10/600,379

Office Action Summary

Applicant(s)TAYLOR, STEVE B. **Examiner**

FIG. 1

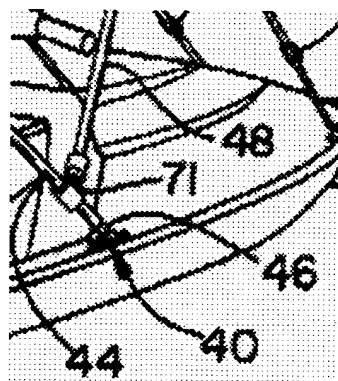
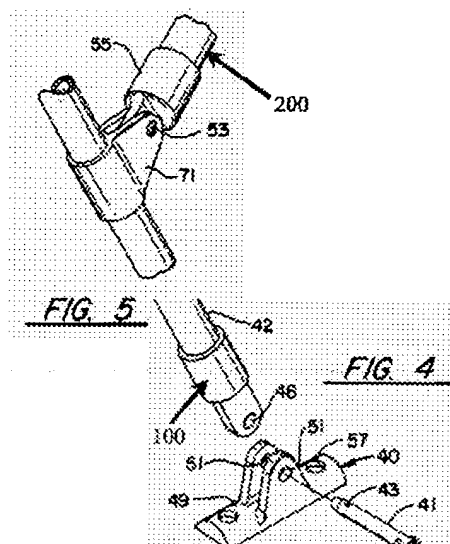
Claim 1. Murray discloses (figs.1, 4, 5) a variably positionable coupler mountable on a curved surface, comprising: a base (40) formed with an upper side and a lower side, wherein the lower side is a substantially flat planar surface; means (57) for mounting the base on the curved surface; a tub (100) adjustably connectable to the base; a plug (42, 71) repositionably attachable to the tub; a neck (55) rotatably insertable in the plug, wherein the neck is formed for securing a shaft (200) to the neck; and a clevis mechanism (clevis connection between 55 and 71) slidably and demountably engageable with the plug and the neck. (Note that while the Murray curved surface does not curve at its point of contact with element 40, it does curve elsewhere and is thus a curved surface within the broadest reasonable interpretation of the claim language).

Claim 2. Murray discloses opposing yokes (tab portions of 40 receiving 41) monolithically extending at substantially right angles from the upper side of the base.

Claim 3. Murray discloses one or more bores (51) formed in the base with a proximal end and a distal end, and further wherein the one or more bores are shaped for removable engagement with a bolt (41). The word "bolt" is taken by the examiner to mean, "a metal rod or pin for fastening objects together" in accordance with Merriam-Webster's Collegiate Dictionary Tenth Edition.

The applicant argues that Murray does not disclose a means for mounting the base on a curved surface. This is not persuasive. Murray discloses that base (40) is mounted (col.3, ll.47-50) to a curved surface (surface of 20). Note that the surface (20) curves as it approaches the bow of watercraft (10). Hole elements (57) are means for accomplishing this mounting in that they can receive fasteners (i.e., screws, bolts, rivets, etc.). The fact that Murray does not explicitly state what type of fastener is used in conjunction with element 57 is irrelevant since claims 1-3 do not positively recite any specific type of fastener.

The applicant argues that Murray does not disclose a tub adjustably connectable the base since the element (100 of marked-up fig.4) is element (55) of figure 5. This is not persuasive. It appears that the applicant does not fully appreciate that figures 4 and 5 show separate sections of the assembly of figure 1. Figures 1, 4 and 5, as depicted together above, show that element 100, while similar in structure to element 55, is in addition to and assembled away from element 55. Specifically, element 100 is located between elements 40 and 71, whereas element 55 is located

The applicant argues that Murray does not disclose a plug. This is not persuasive. Murray discloses a plug (comprised of 42 and 71) repositionably attachable to the tub (100); a neck (55) rotatably insertable in the plug, wherein the neck is formed for securing a shaft (200) to the neck. The fact that the Murray plug is of a two-piece construction is irrelevant since the applicant does not positively claim one-piece construction.
